**TO:** Chairman Mroch; Planning and Zoning Commission  
**FROM:** Josh Wray, Assistant to the Village Manager  
**FOR:** Planning and Zoning Commission Meeting on August 8, 2022  
**RE:** Final Plat for Neighborhood R in Prairie Ridge

**Re: *Prairie Ridge Neighborhood R – 2<sup>nd</sup> Final Engineering and Plat Review  
Village of Hampshire***

# FINAL PLAT OF SUBDIVISION FOR PRAIRIE RIDGE - NEIGHBORHOOD R

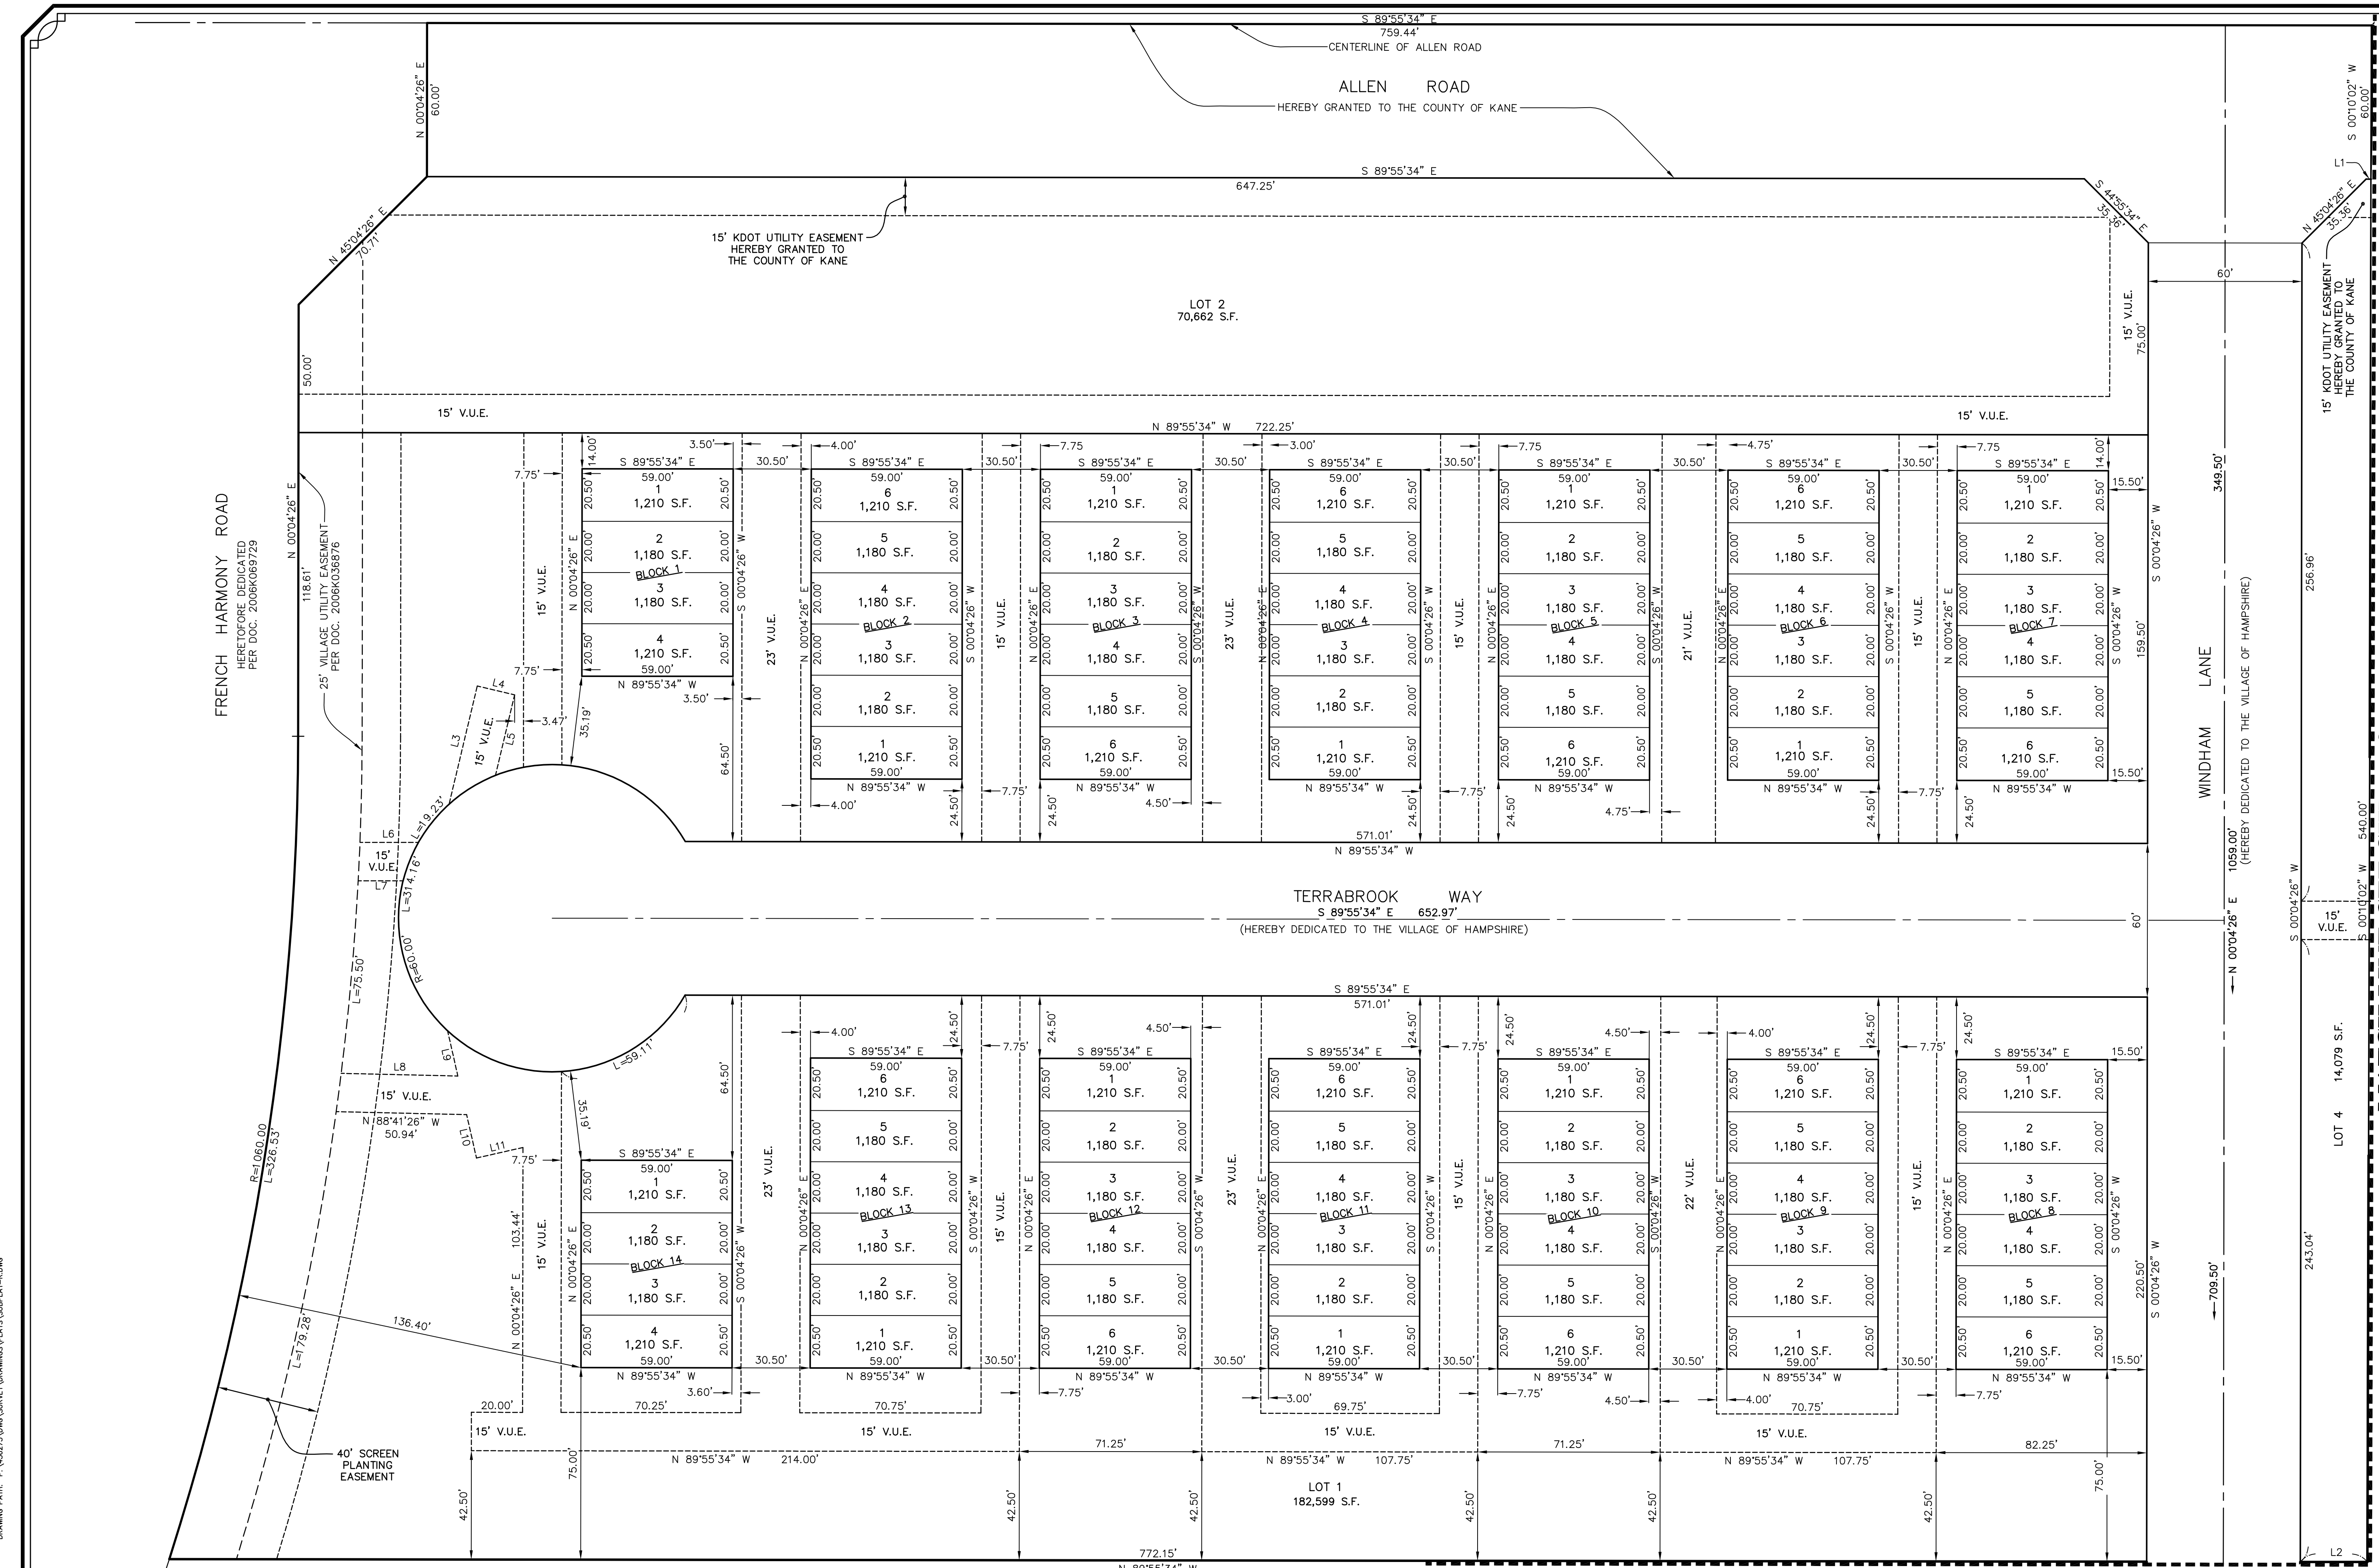
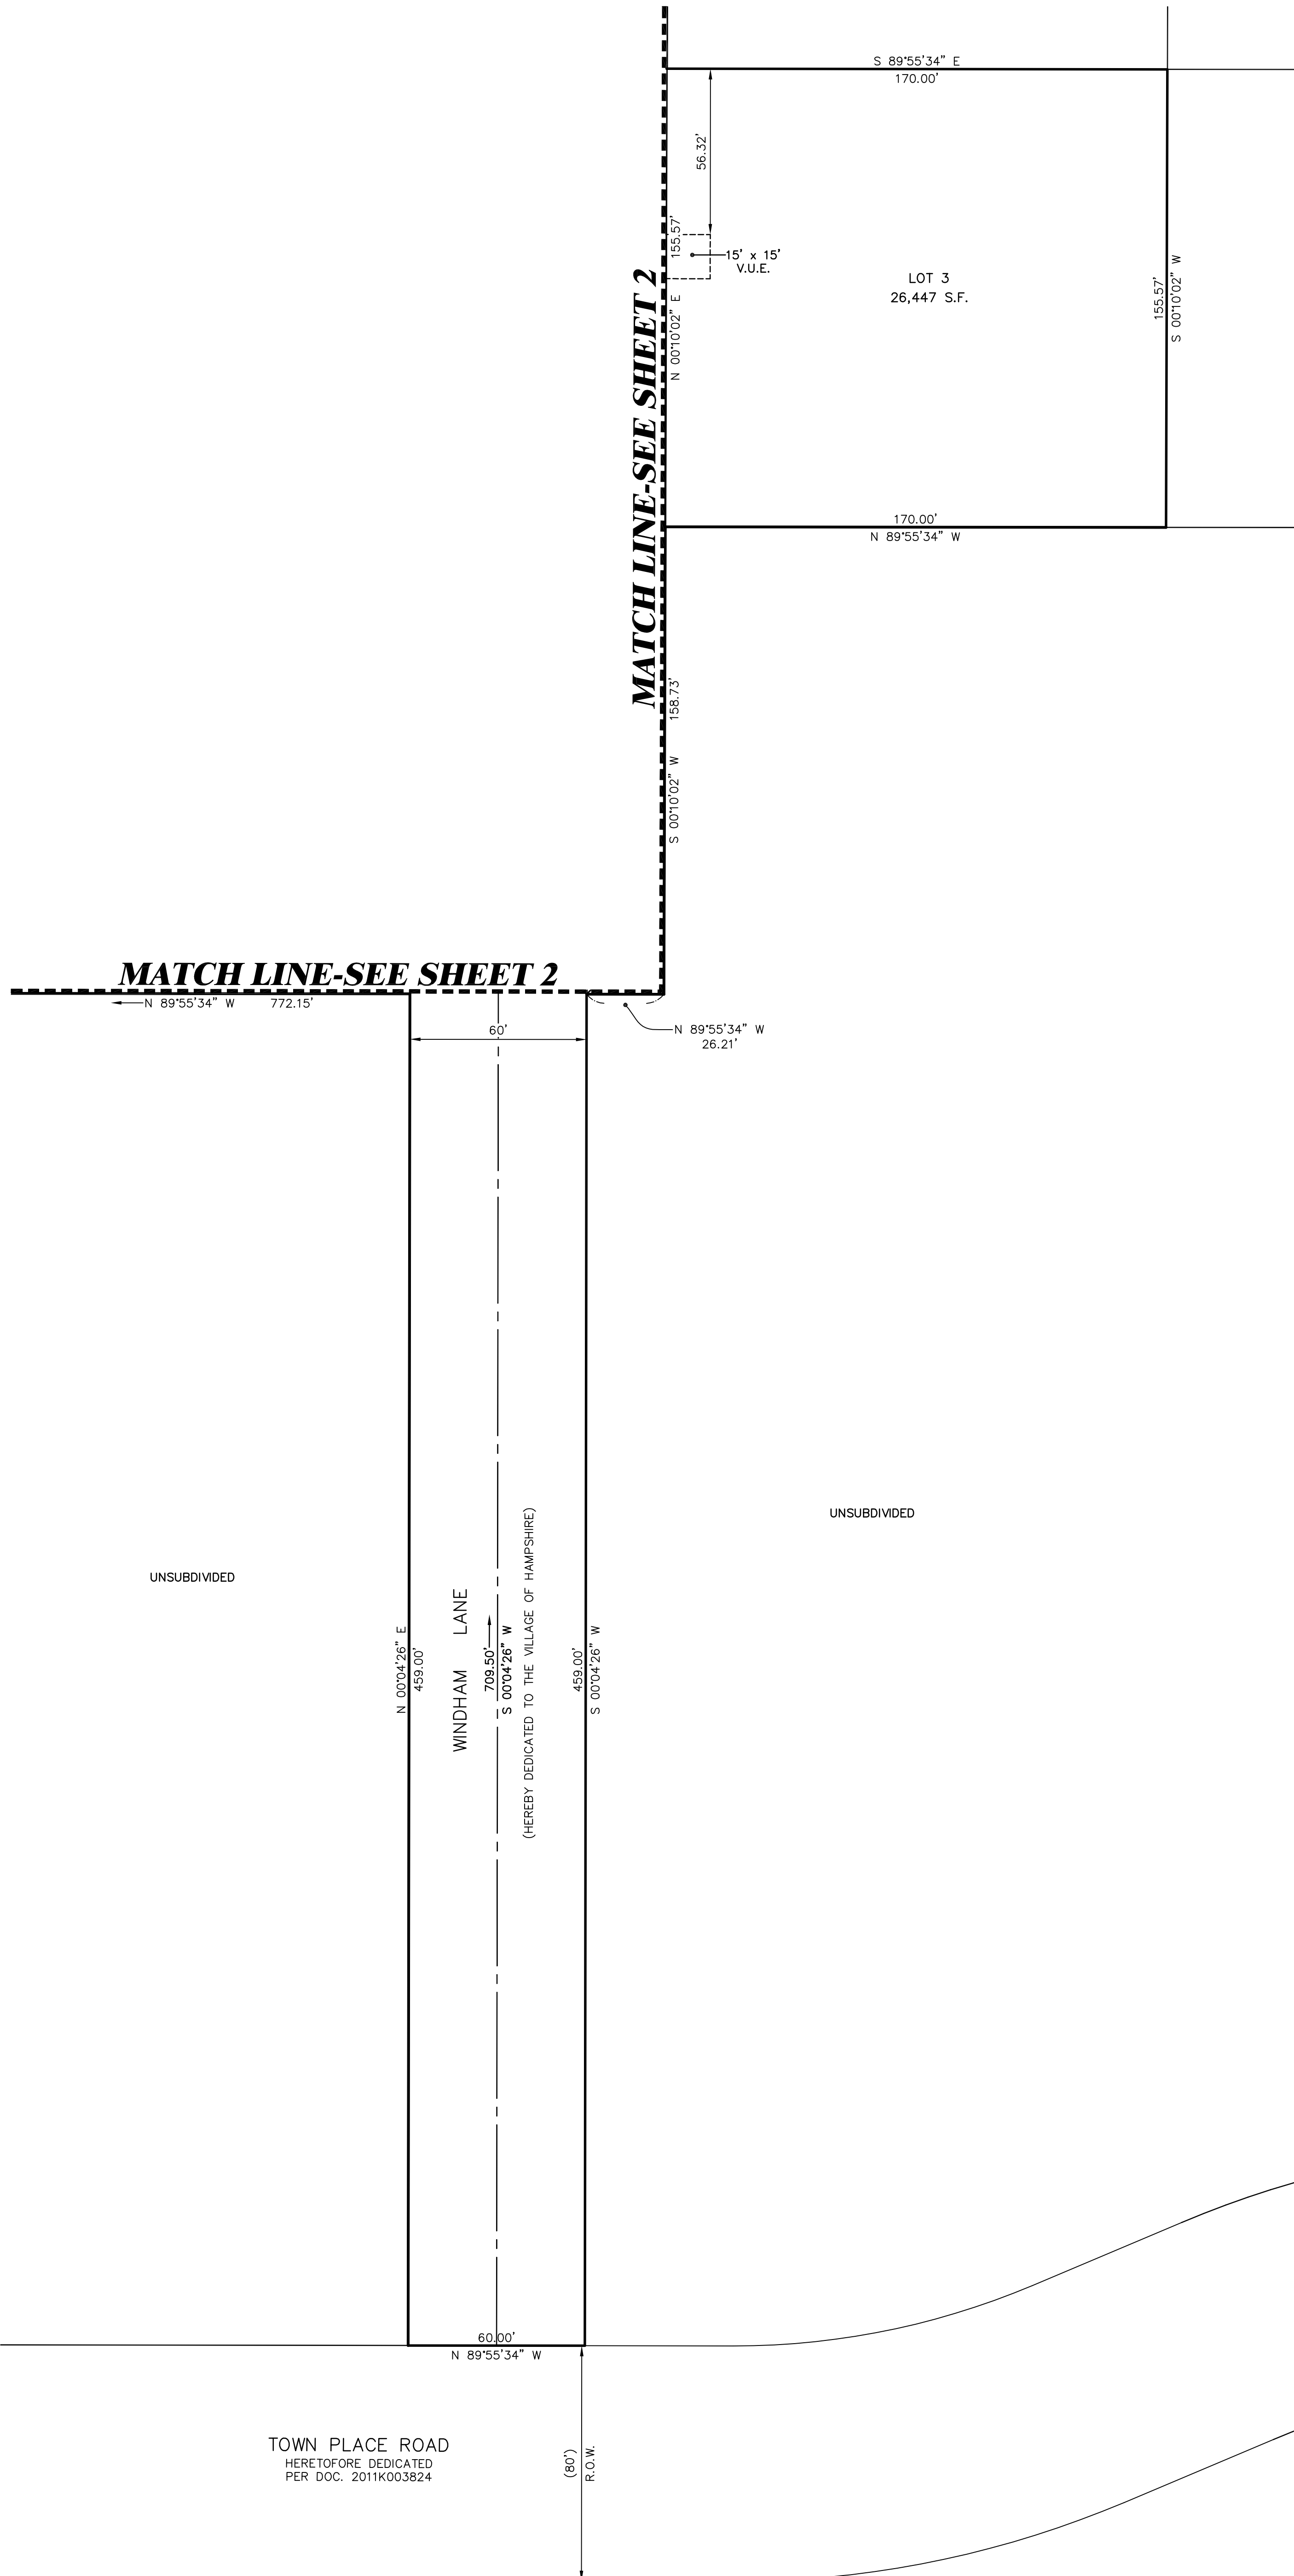
18. An easement document for the storm sewer easement along Town Place Road needs to be submitted for review. This easement will need to be approved and recorded before or at the same time as the plat of subdivision.
19. The text under Allen Road from "Hereby Granted to Kane County" to Hereby Dedicated to Kane County
